CALL NO. 102
CONTRACT ID NO. 141041
ADDENDUM # 1

Subject: Pulaski County, HSIP 5105 (035)
Letting August 22, 2014

- (1) Revised - Plans - R1, R2, R2A, R2B, R3, R5, R11, & X14
- (2) Added - Special Notes - Pages 17(a)-17(c) of 105
- (3) Revised - Bid Items - Pages 104-105 of 105

PULASKI COUNTY
KY 70 IMPROVEMENTS AT BUCK CREEK
HSIP 5105 (035)
FD52 100 0070 009-010

SCALE: 1"=5'

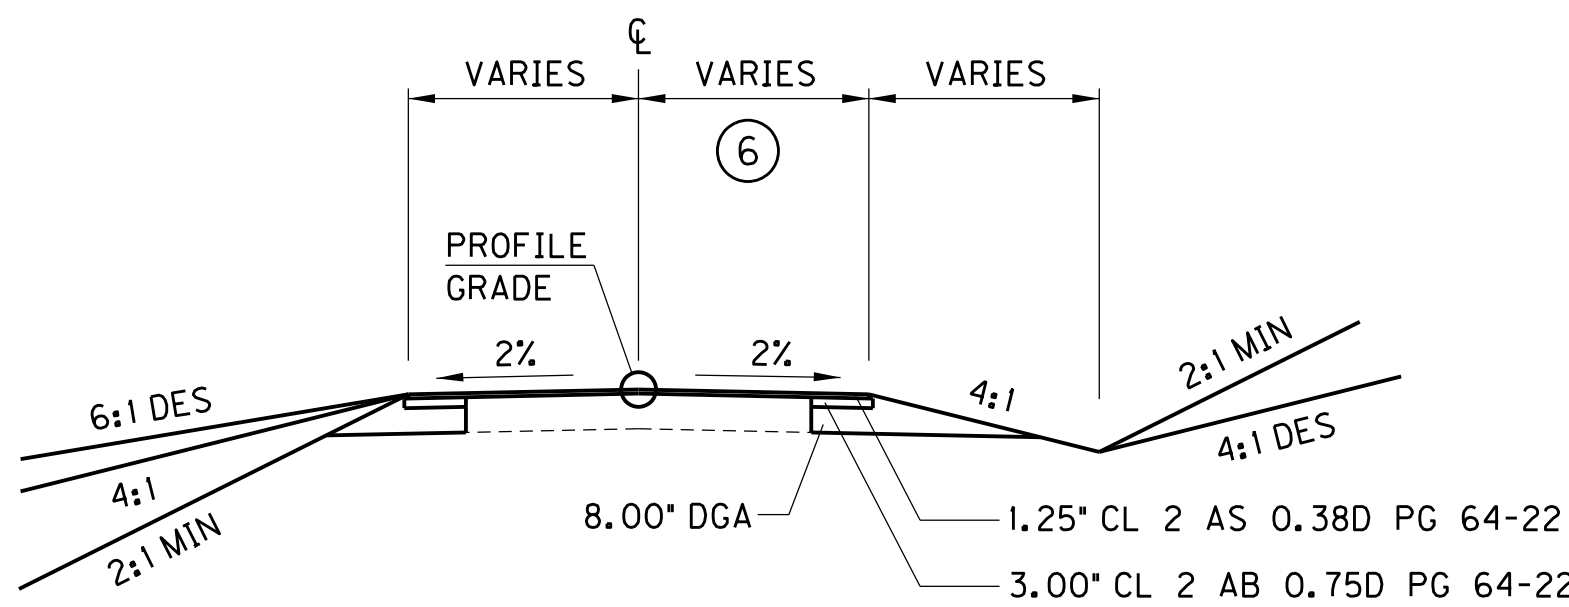
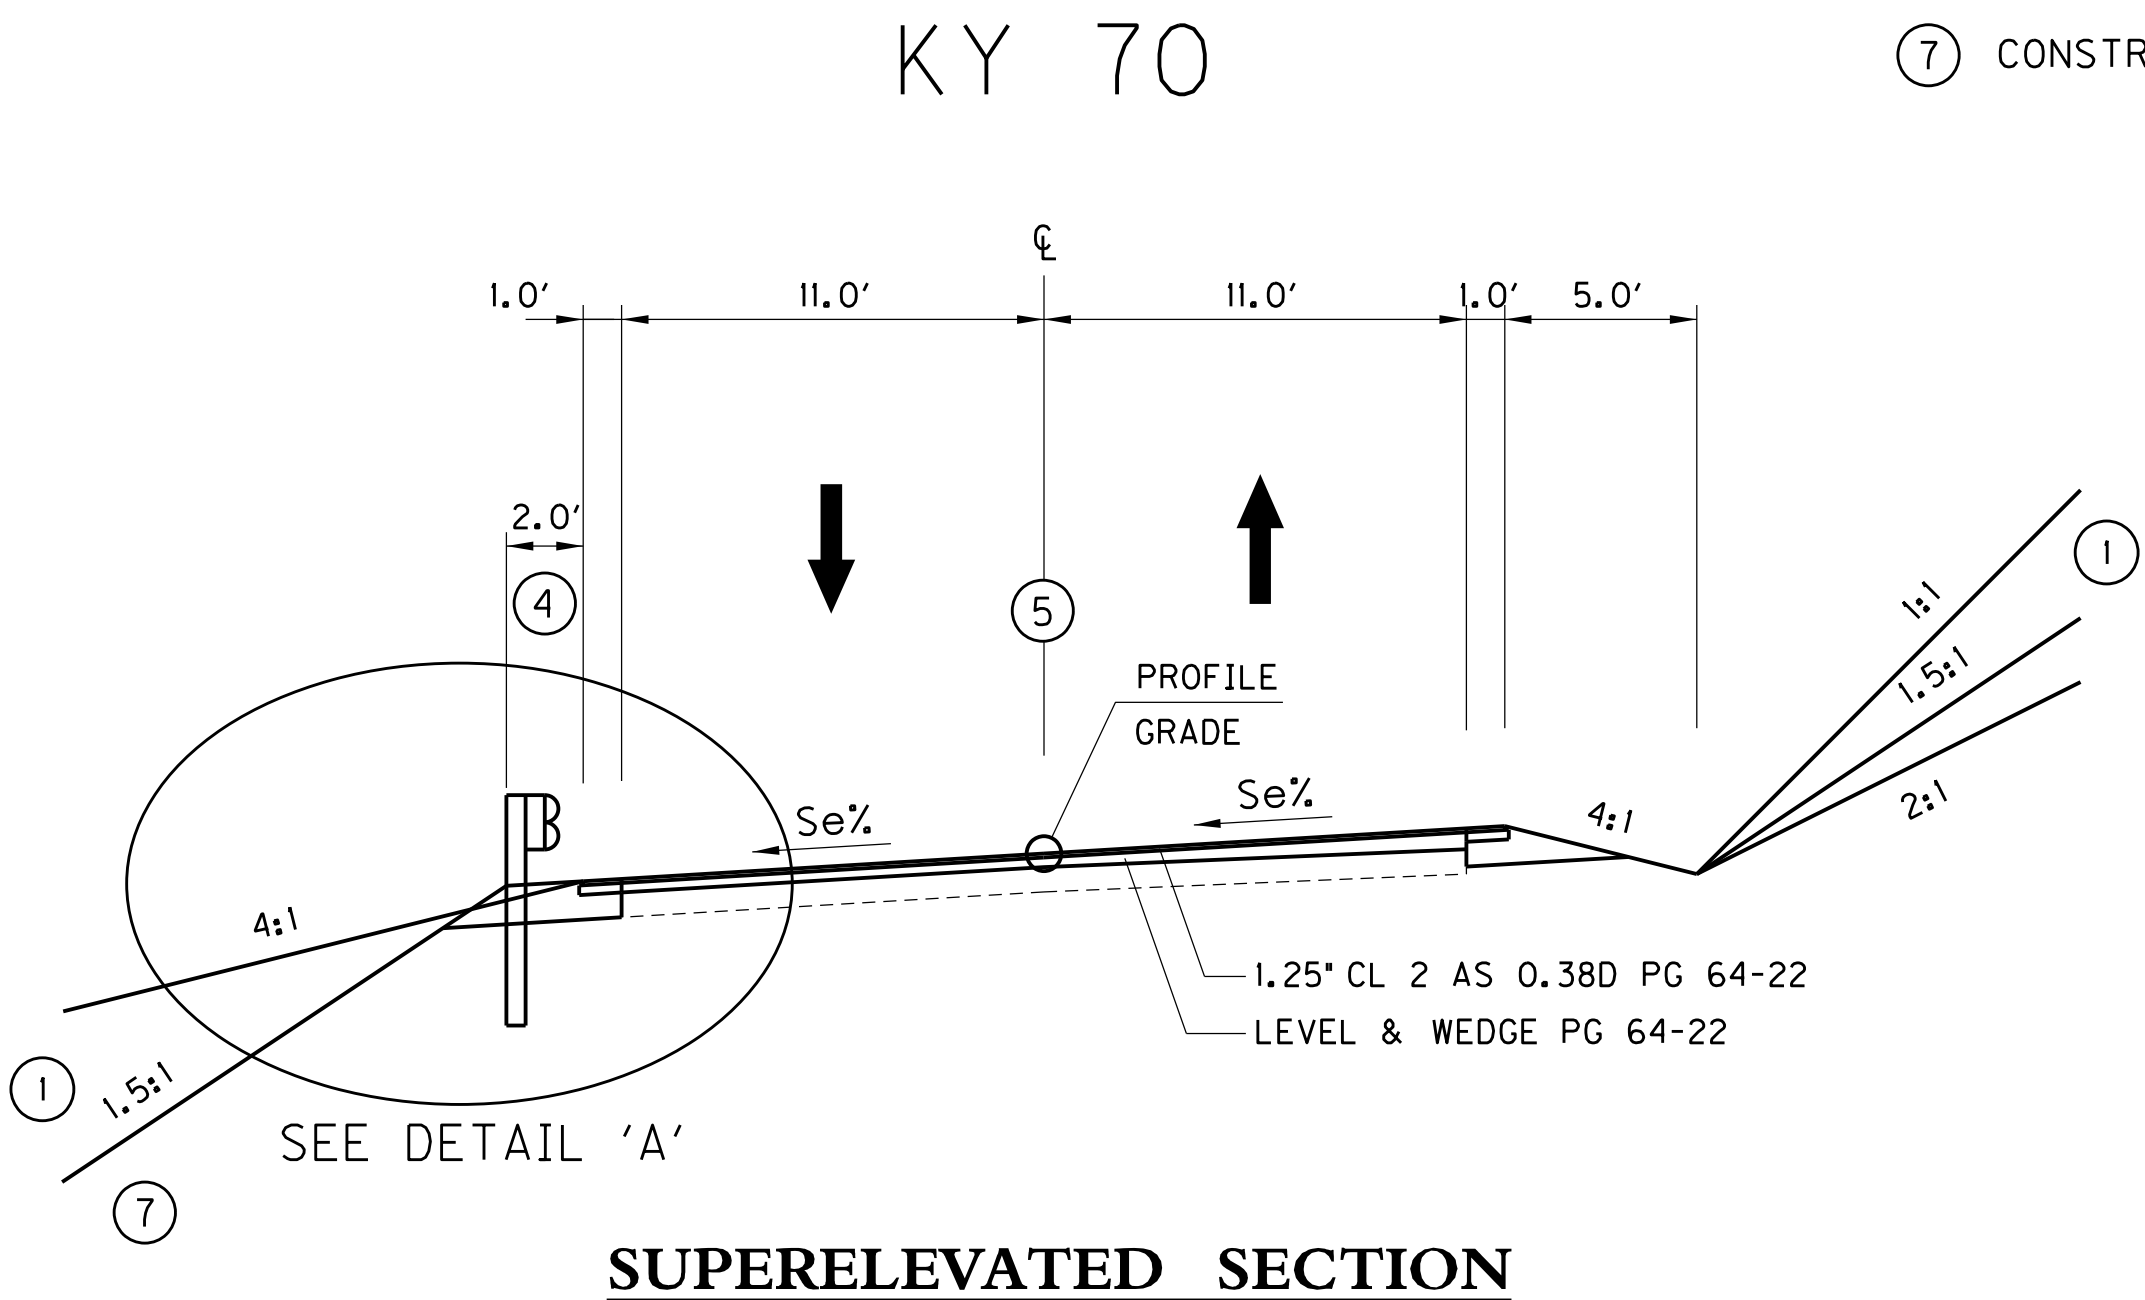
CHANGED NOTE TO INDICATE 9 FT POSTS

COUNTY OF	ITEM NO.	SHEET NO.
PULASKI	8-926.00	R2B

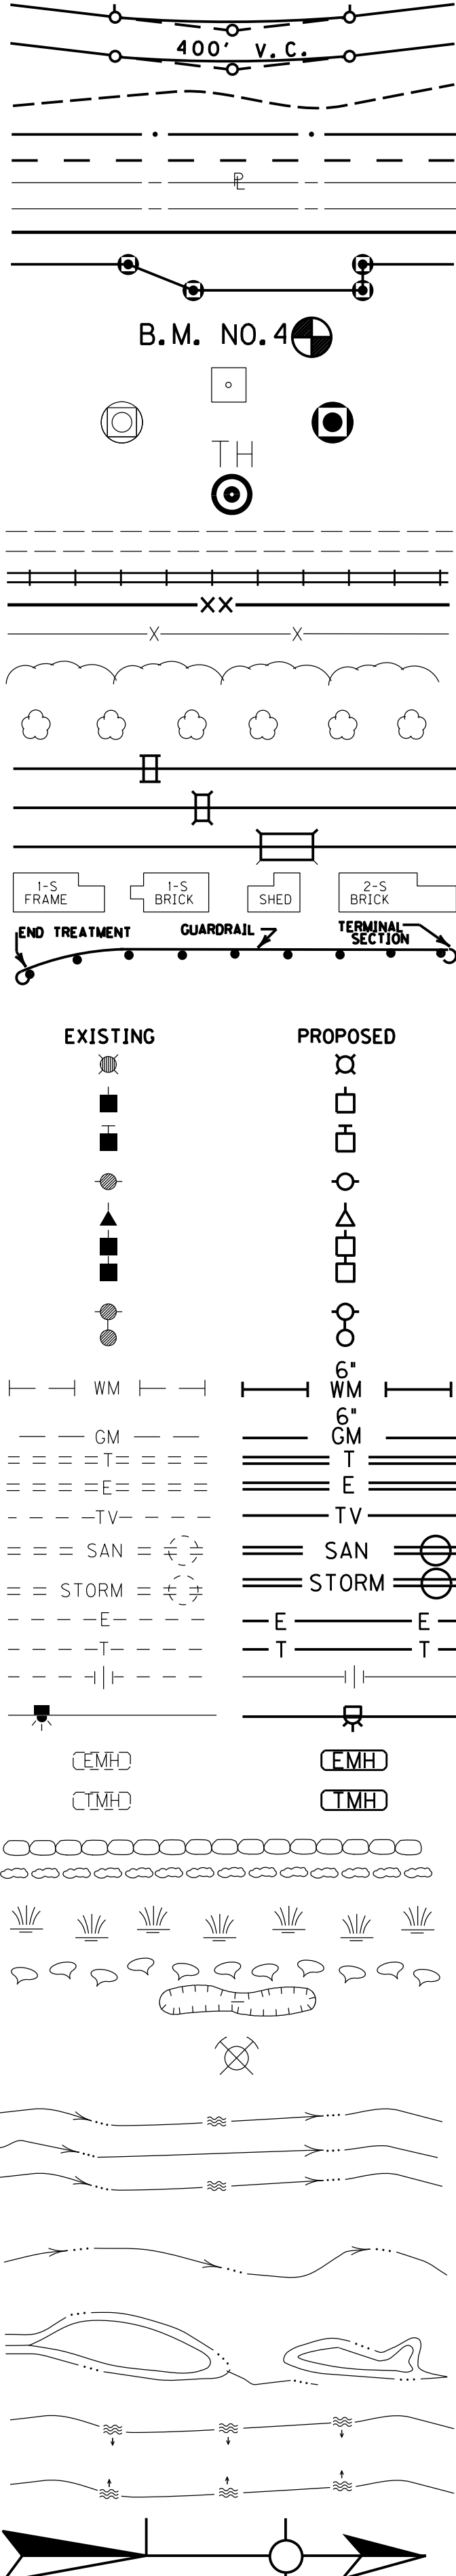
ADDED SPECIAL NOTE REGARDING SILT TRAP TYPE B

- A TEMPORARY SILT TRAP TYPE B WILL BE INSTALLED WITHIN THE UNNAMED TRIBUTARY OF BUCK CREEK (OUTSTANDING STATE RESOURCE WATER) AT THE DOWNSTREAM END OF THE CULVRT EXTENSION AREA LOCATED AT STATION 18+82.27. THIS MEASURE WILL BE USED TO RETAIN SEDIMENT GENERATED AS A RESULT OF THE CULVERT EXTENSION AND WILL MINIMIZE THE DOWNSTREAM TRANSPORT OF SEDIMENT. FOLLOWING COMPLETION OF CONSTRUCTION, THE SILT TRAP WILL BE REMOVED AND THE AREA WILL BE RETURNED TO PRE-CONSTRUCTION CONTOURS.

COUNTY OF	ITEM NO.	SHEET NO.
PULASKI	8-926.00	R3

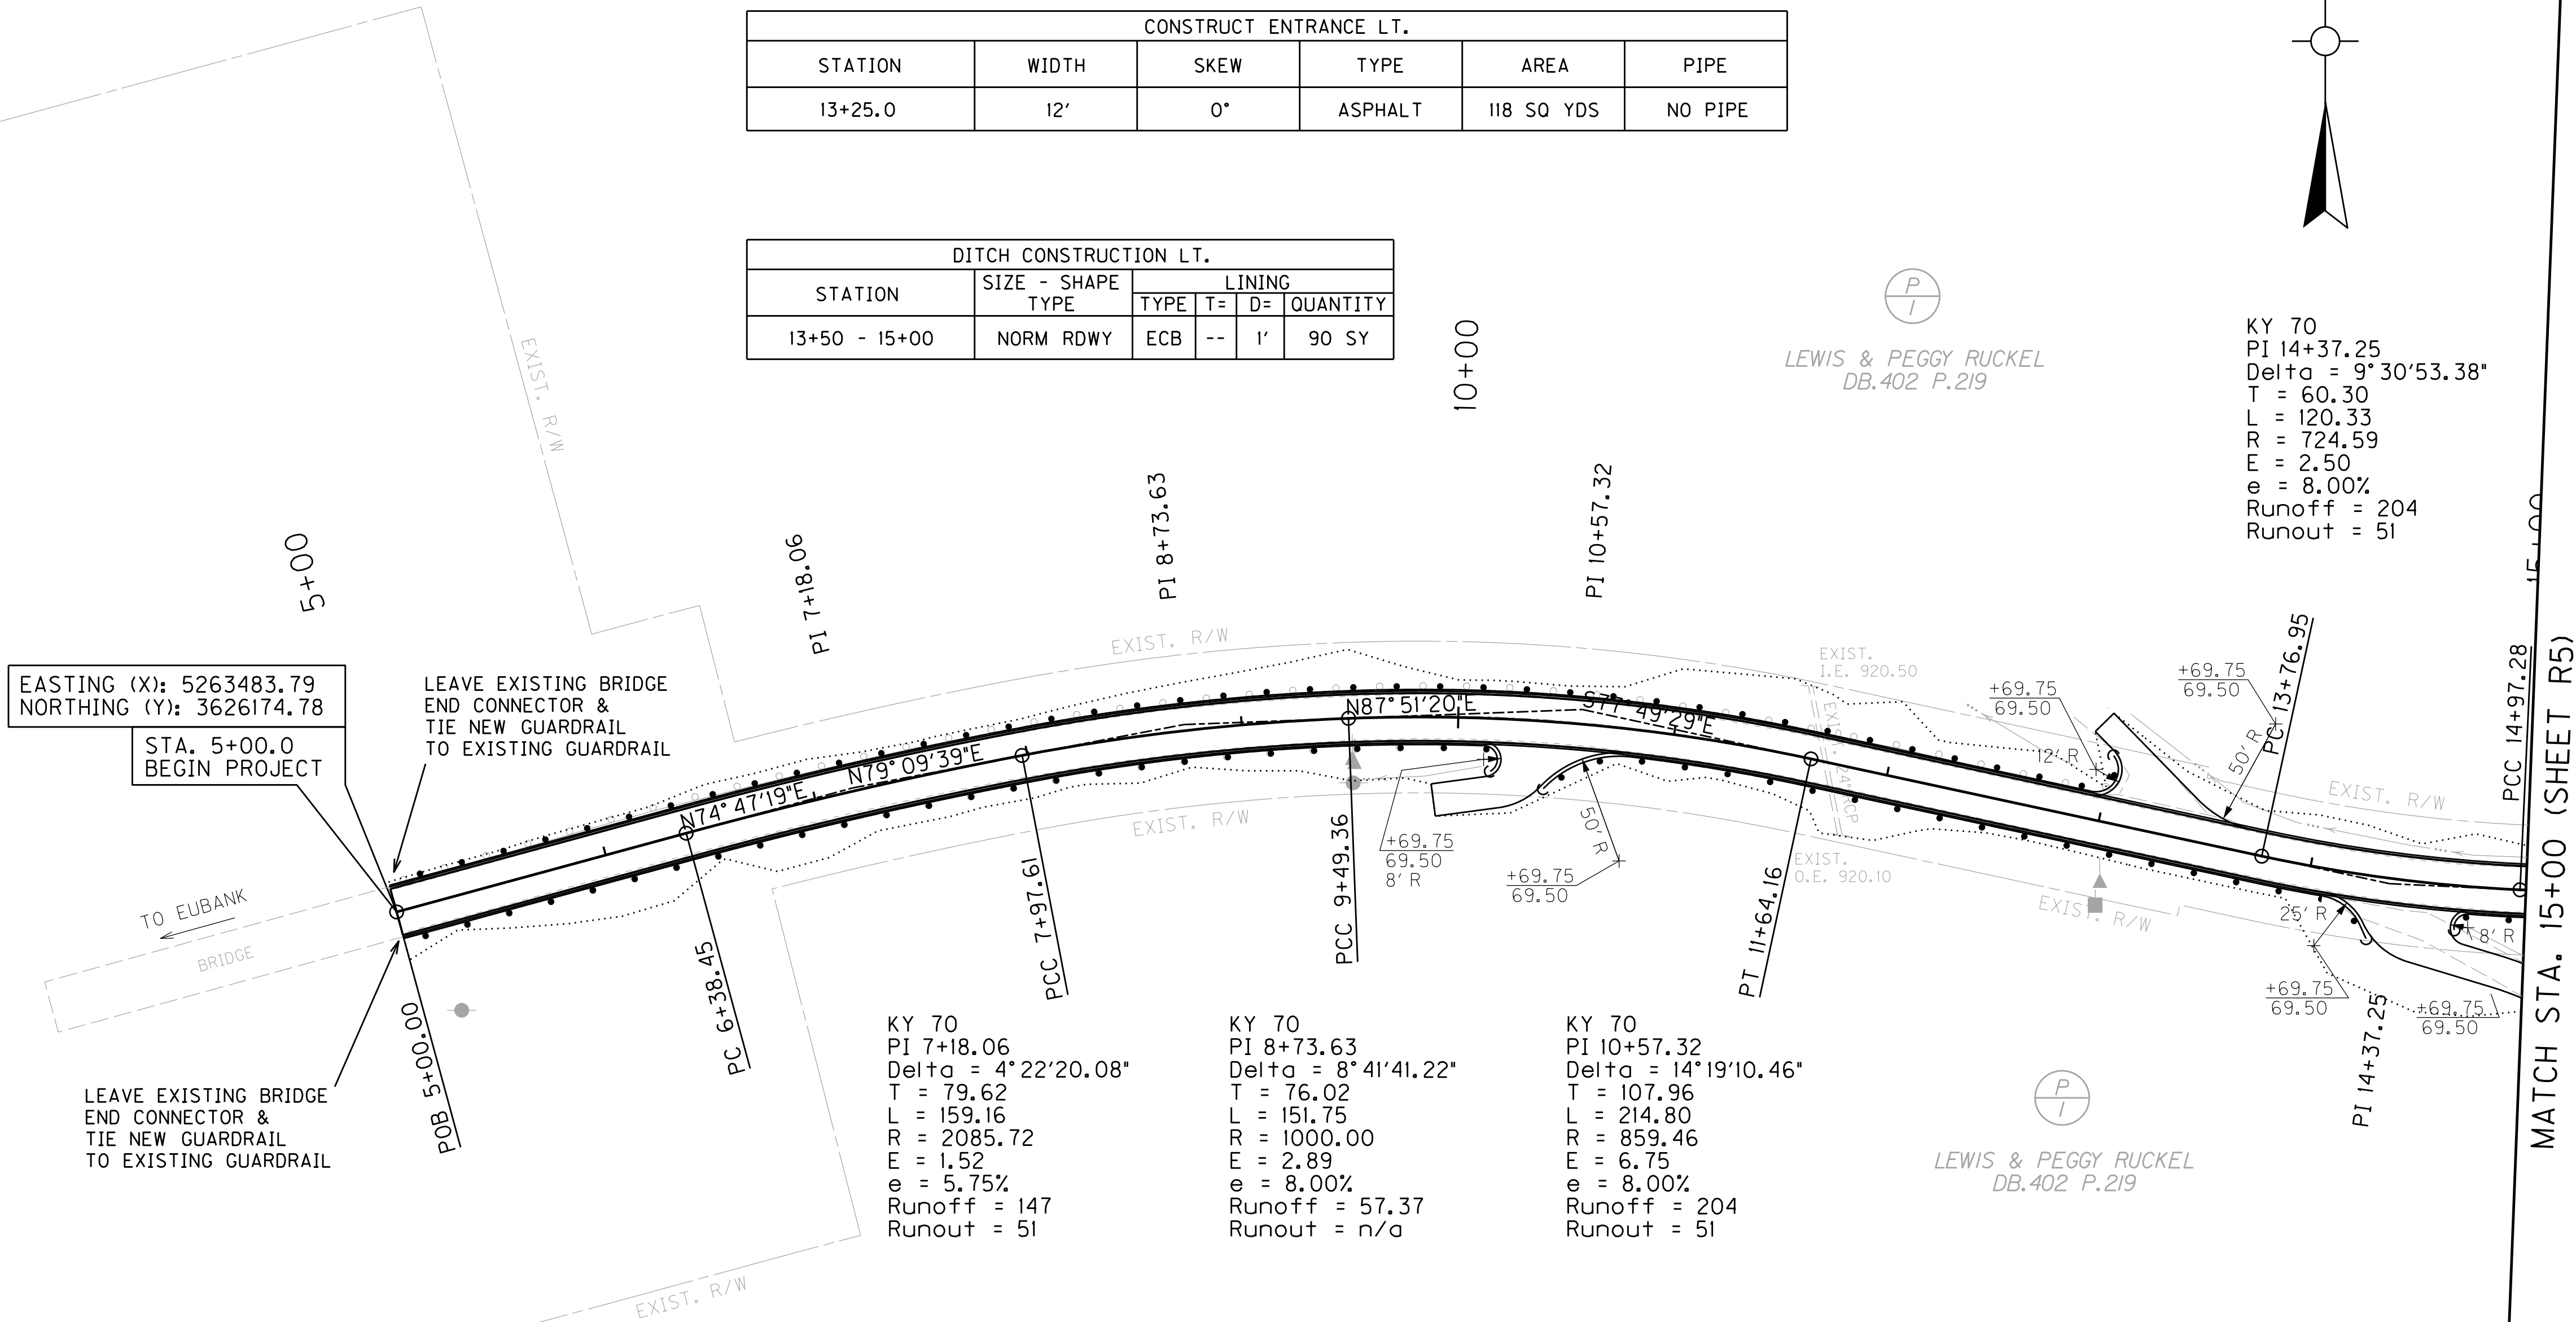
CHANGED NOTE TO INDICATE 9 FT GUARDRAIL POSTS

GUARDRAIL CONSTRUCTION RT.					
STATION	TYPE	LENGTH	END TREATMENT		
			STATION	TYPE	
5+00.0 - 10+15.7	STEEL W-BEAM, S-FACE (9 FT POST)	525.0'	5+00.0	CONNECT TO EXIST RAIL	
			10+15.7	TERMINAL SECTION NO. 1	
10+41.4 - 14+30.0	STEEL W-BEAM, S-FACE (9 FT POST)	400.0'	10+41.4	TERMINAL SECTION NO. 1	
			14+30.0	TERMINAL SECTION NO. 1	
14+68.6 - 15+00.0	STEEL W-BEAM, S-FACE (9 FT POST)	37.4'	14+68.6	TERMINAL SECTION NO. 1	
			15+00.0	N/A (CONT'D NEXT SHEET)
